G.O. No. 1869	Press.
B.P. No.	Mis.
Dated 5-7-1883	198.

READ--the following letter from G. T. WALCH, Esq., Officiating Superintending Engineer, First Circle, to the Chief Engineer, Public Works Department, dated Dowlaishweram, 19th June 1883, No. 856 G.D.

Extract from the Progress Report of Works in charge of Supervisor J. Mahony, in charge of Dumagudem Sub-division, Godavari Eastern Division, from 21st to 31st May 1883.

Dumagudem Anicut

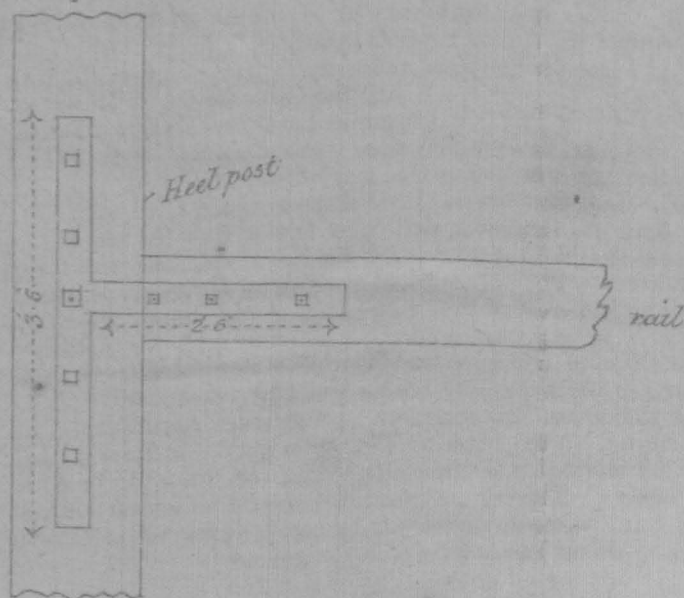
There is no indication whatever of decay in the heel posts where they enter the pintle sockets (nor elsewhere), and it is not understood how such a report ever originated. The only part at all decayed is the heel-post tender of the second rail (from sill) of the right leaf; this has opened a little from the heel, and the corner of the heel has cracked away; the part is probably still strong and sound enough, but, as a precaution, two — straps are to be bolted through to rail and heel post as per sketch.

Straps to be countersunk to be $3\frac{1}{2}$ " broad $\times$ $\frac{3}{4}$ " thick and bolted through each other by 8 bolts and nuts, $\frac{3}{4}$ " diameter would do, but the Overseer has only $\frac{1}{2}$ " and 1", so the bolts can be 1" diameter. The gates are to be thoroughly cleaned before being tarred; all crevices and cracks to be well cleaned and filled in with tar, with tar and dammer where cracks are wide enough to take it. The crack in left heel post, alluded to by Superintending Engineer to be so treated, valve shutter bearings to be looked to.

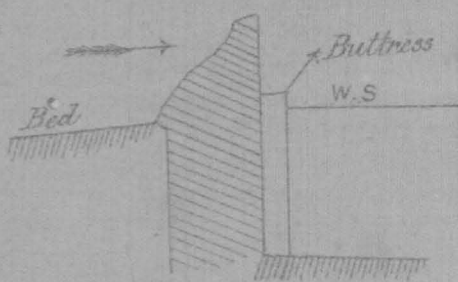
I should think, of old standing; and, as the river bed below is only a couple of feet below crest, nothing seems to be required in the way of filling in. From the left wing for 1077' is the shoot which is in fair order, the long sloping apron near its W end to be pointed where necessary, and the masonry repairs to masonry provided in D. Venkataswamy's estimate to be carried out if possible. At present, owing to pools of water above and below, it is impossible to see where these repairs are required. From the end of the shoot

Trifling ones.

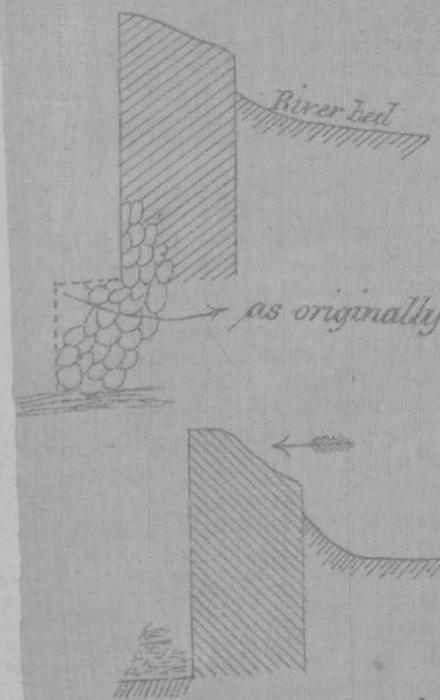
said to be in the rear face of the anicut; of these, one $21' \times 4' - 6' \times 12'-0$ is said to be under the

anicut scouring sluices, but its existence is greatly doubted, and when the water falls to a minimum in May, the Overseer will make a special report on the subject.

The other four places supposed to require repairs were pointed out by the lascar, who with Overseer Venkataswamy measured them; but only in one place, after most careful search in rear of Section No. 4, could anything resembling a hole be discovered, and it (this hole) was only in the basement of the anicut. Repairs to this basement as per Venkataswamy's estimate are to be done. At present the basement is somewhat, as per sketch, a good deal broken down in places; there is no immediate danger, but the action of the water when there is but little going over the anicut will loosen more of the small rubble of which the basement is composed. Rear face of anicut to be pointed where required as shown, pebble concrete grouting being used where the spaces are large enough to take it.
